Re: Sunset Apartments
SE Corner of Sunset and 82th St.
Traffic Circulation Layout
Engineer's Stamp 09-13-22 (L10-D032)

Based upon the information provided in your submittal received 09-15-22, the above referenced plan cannot be approved for Conceptual TCL until the following comments are addressed:

09-13-22 RONALD R. BOHANNAN P.E. #7868	SUNSET APARTMENTS ALBUQUERQUE, NM	DRAWN BY pm
	CONCEPTUAL TRAFFIC CIRCULATION LAYOUT	DATE 9-7-22
	TIERRA WEST, LLC 5571 MIDWAY PARK PL. NE ALBUQUERQUE, NEW MEXICO 87109 (505) 858-3100 www.tierrowestllc.com	SHEET #
		JOB # 2022028

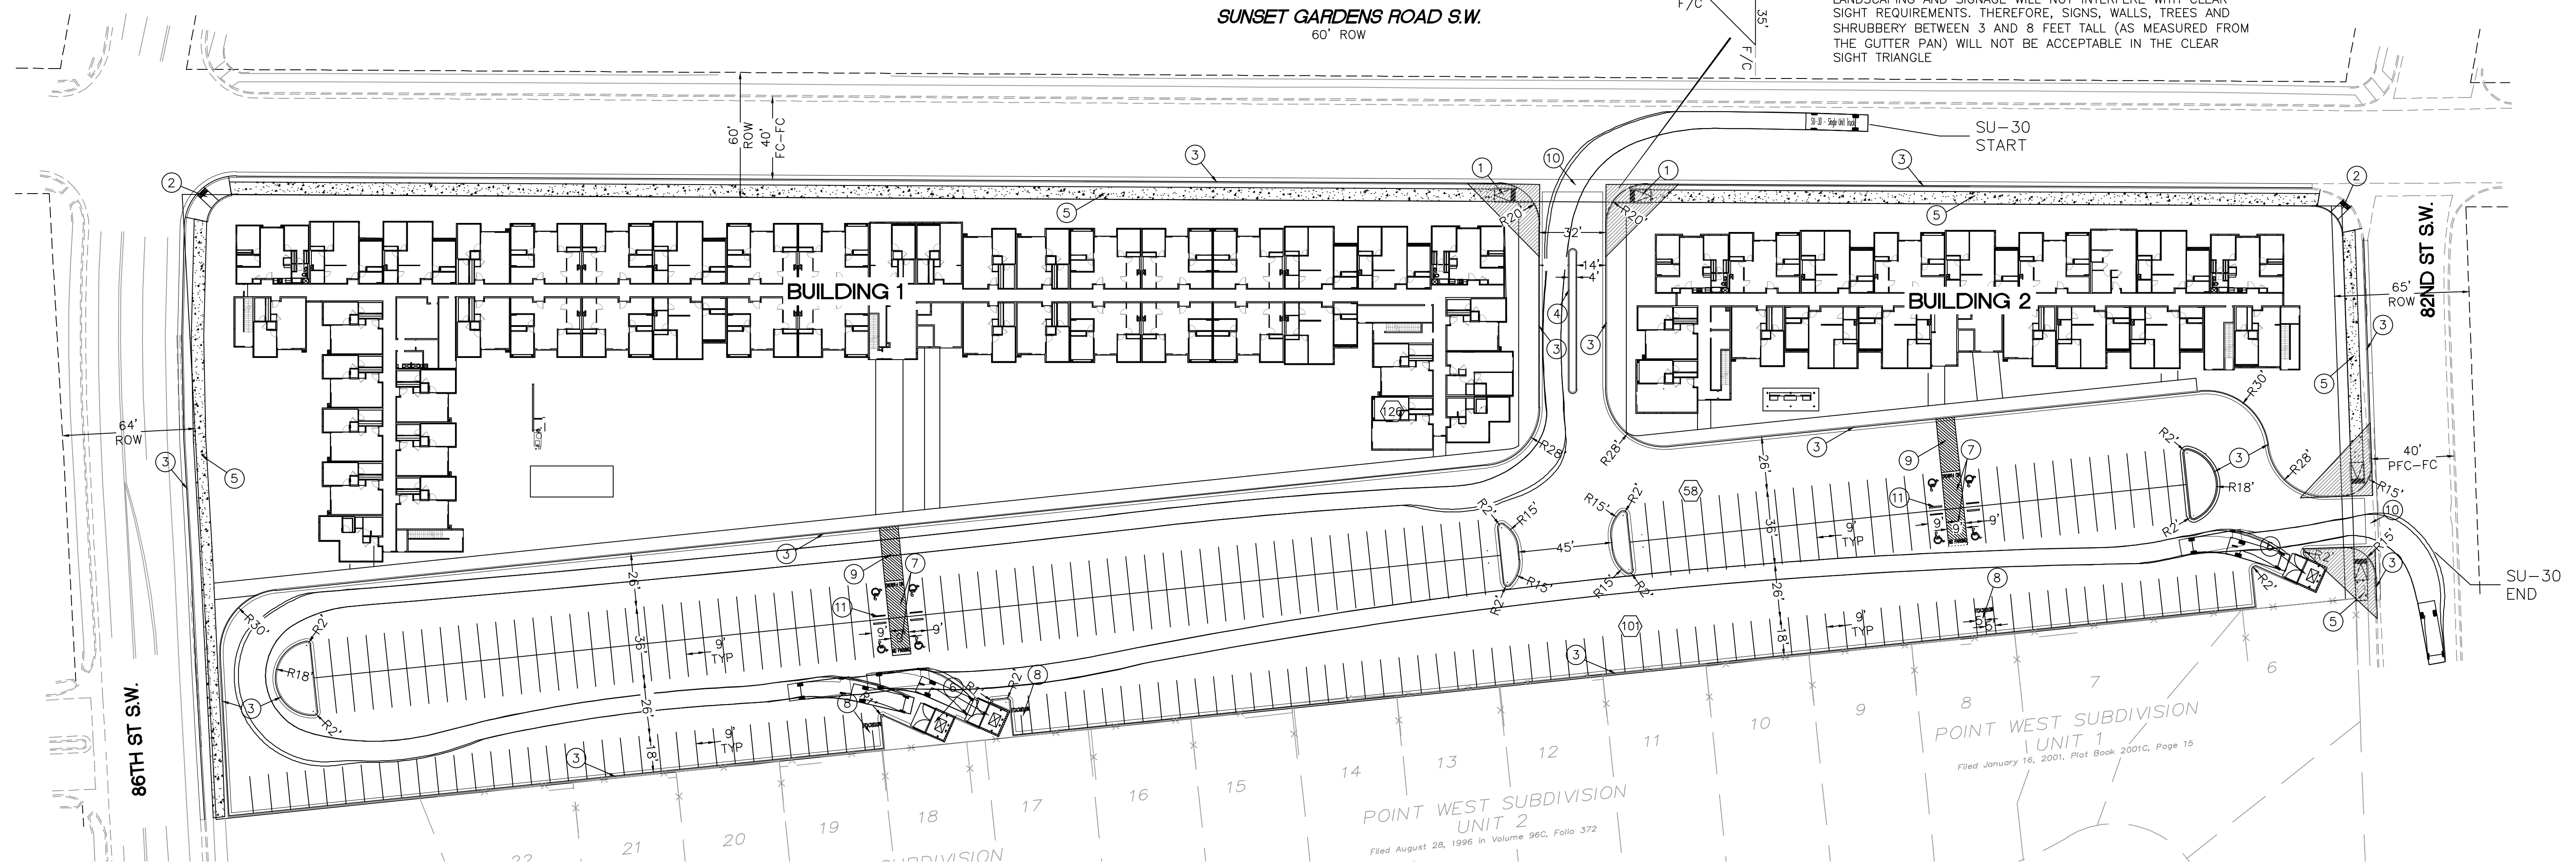
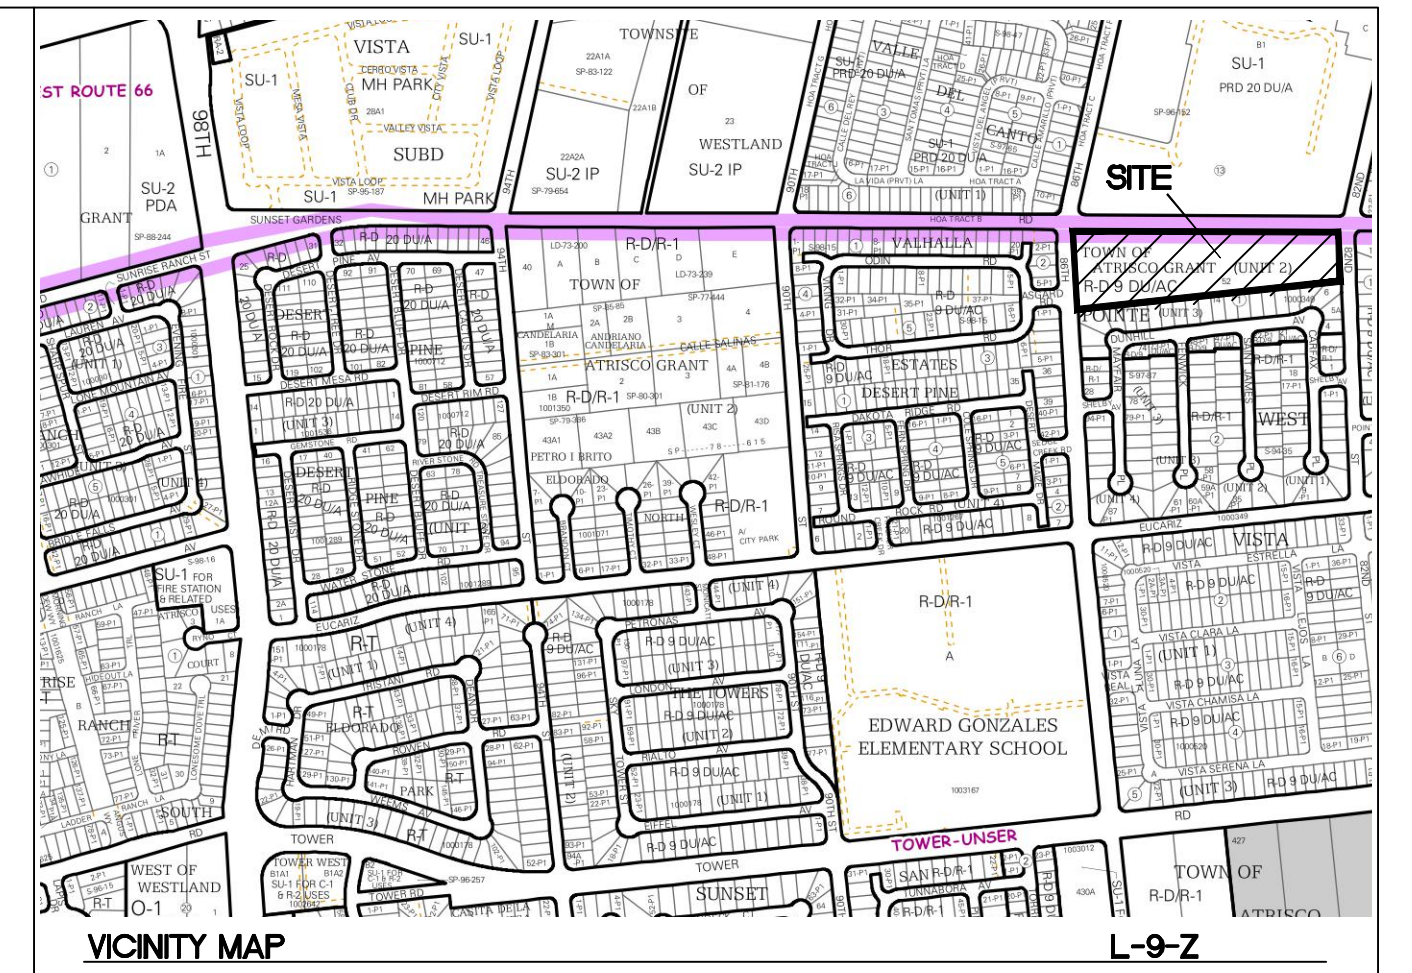
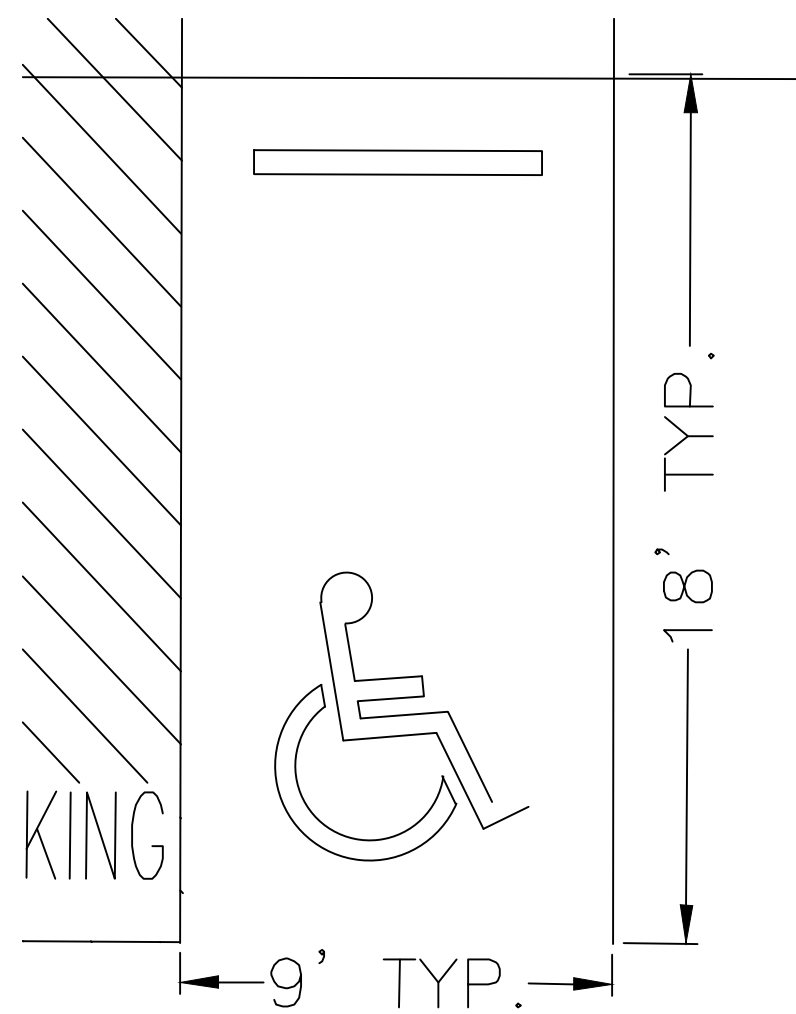
1. Please show the North Arrow on the site plan.
2. Clarify existing property lines and proposed property lines.
3. The ADA accessible parking sign must have the required language per 66-7-352.4C NMSA 1978 **"Violators Are Subject to a Fine and/or Towing."** Please call out detail and location of signs.

4. The ADA accessible spaces must include an access aisle. Van accessible aisles should be 8ft wide; all others should be 5ft wide.
5. Please provide details for all proposed pavement marking and signs (ADA and Motorcycle parking spaces).

6. Provide the width for driveway access off 82th st.
7. Key note 10: please reference COA std dwg 2426 for the proposed driveways accesses.
8. Key note 5: please reference COA std dwg 2430 for the proposed sidewalk.

9. Key note 2: provide details and call out COA std dwg for the proposed ADA ramps.
10. ADA curb ramps must be updated to current standards and have truncated domes installed.

11. All bicycle racks shall be designed according to the following guidelines:
 - a. The rack shall be a minimum 30 inches tall and 18 inches wide.
 - b. The bicycle frame shall be supported horizontally at two or more places. Comb/toaster racks are not allowed.

- c. The rack shall be designed to support the bicycle in an upright position. See the IDO for additional information.
 - d. The rack allows varying bicycle frame sizes and styles to be attached.

- e. The user is not required to lift the bicycle onto the bicycle rack.
- f. Each bicycle parking space is accessible without moving another bicycle.
- 12. Bicycle racks shall be sturdy and anchored to a concrete pad.

- 13. A 1-foot clear zone around the bicycle parking stall shall be provided.
- 14. Bicycle parking spaces shall be at least 6 feet long and 2 feet wide.

- 15. Per the IDO, a 6 ft. wide ADA accessible pedestrian pathway is required from the public sidewalk to the building entrances. Please clearly show this pathway and provide details.

- 16. Per DPM, a 6 ft. wide ADA accessible pedestrian pathway is required from the ADA parking stall access aisles to the building entrances. Please clearly show this pathway and provide details.

- 17. ADA accessible pedestrian pathway should not be placed behind parking space or adjacent to a vehicular way. Vehicle and pedestrian/wheel chair conflicts should be avoided as much as possible.

- 18. Define ADA pathways by labeling of ramps, flush pavement, dimensioning of pathways, doorways, etc.
- 19. All sidewalks along streets should be placed at the property line.

- 20. Parking areas shall have barriers to prevent vehicles from extending over public sidewalk, public right-of-way, or abutting lots.
- 21. Refuse vehicle maneuvering shall be contained on-site. The refuse vehicle shall not back into the public right of way. provide a copy of refuse approval.

- 22. Provide a copy of Fire Marshal approval.
- 23. It is not apparent what type of pavement surface is being proposed. A hard driving surface will be required as part of this proposed project for parking area and drive aisles.

- 24. Please specify the City Standard Drawing Number when applicable.
- 25. Provide notes showing what work is included and on the work order and the private work on site.

- 26. Work within the public right of way requires a work order with DRC approved plans.
- 27. Please add a note on the plan stating "All improvements located in the Right of Way must be included on the work order."
